### **Amendments to the Drawings**

The attached sheets of drawings include changes to Figure 2 and 3, and Figures 4, 5, and 6. The first sheet, which includes Figures 2 and 3, replaces the original sheet including Figures 1-3. In figure 2, a portion of the left panel sleeve have been removed to show the inner liner 40 as it nests within the sleeve 20; note elements 42, 44, 24, and 30. Elements 56 and 22 have been added, and one of the two sidewalls has been changed from 28 to 26. In Figure 3, previously omitted element 42 has been added.

Fig 4

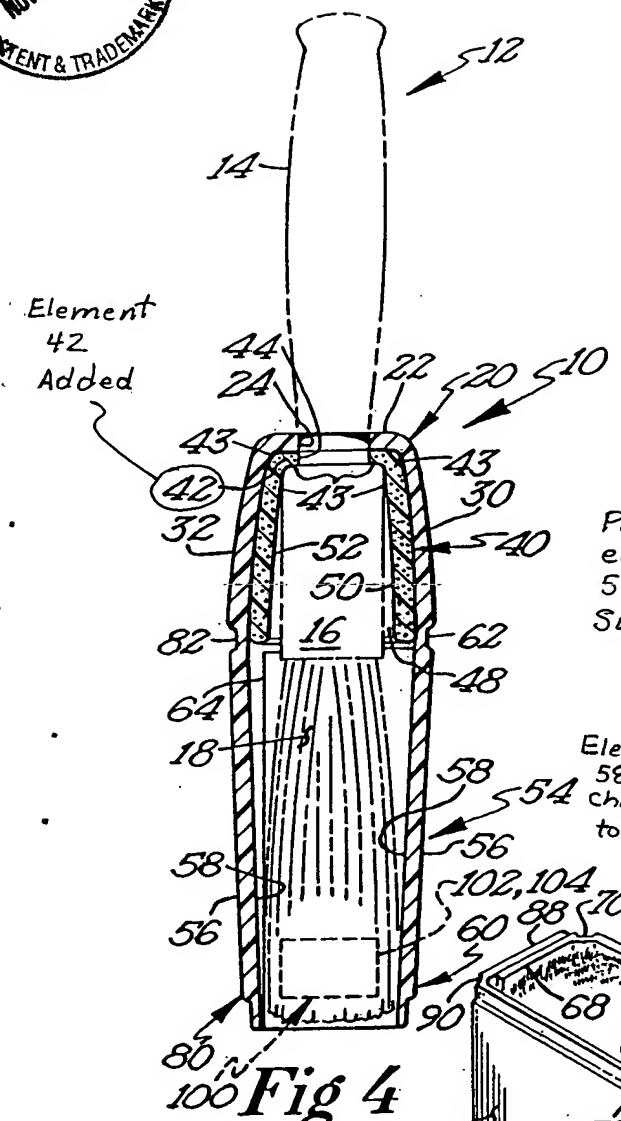
The second sheet, which includes Figures 4, 5, and 6, replaces the original sheet including Figures 4-6. In Figure 4, previously omitted element 42 has been added. In Figures 5 and 6, element 56 has been renumbered to 58, while element 58 has been renumbered to 56, so that they comport with numbers 56 and 58 in the other figures.

Fig 5

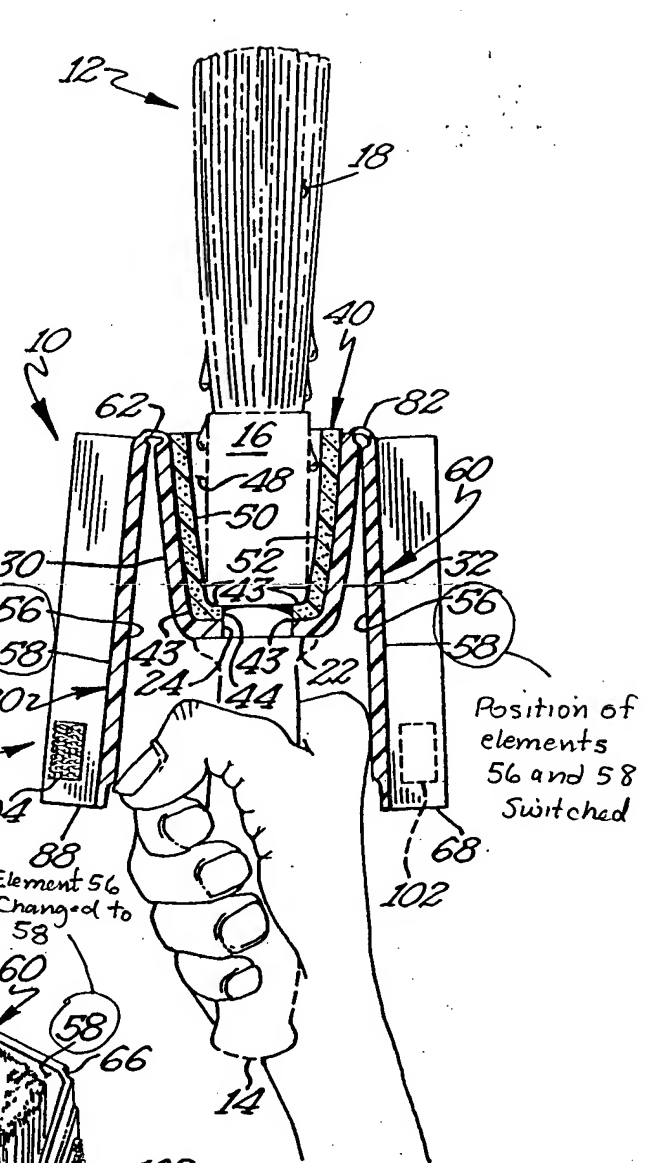
Element 58 changed to 56
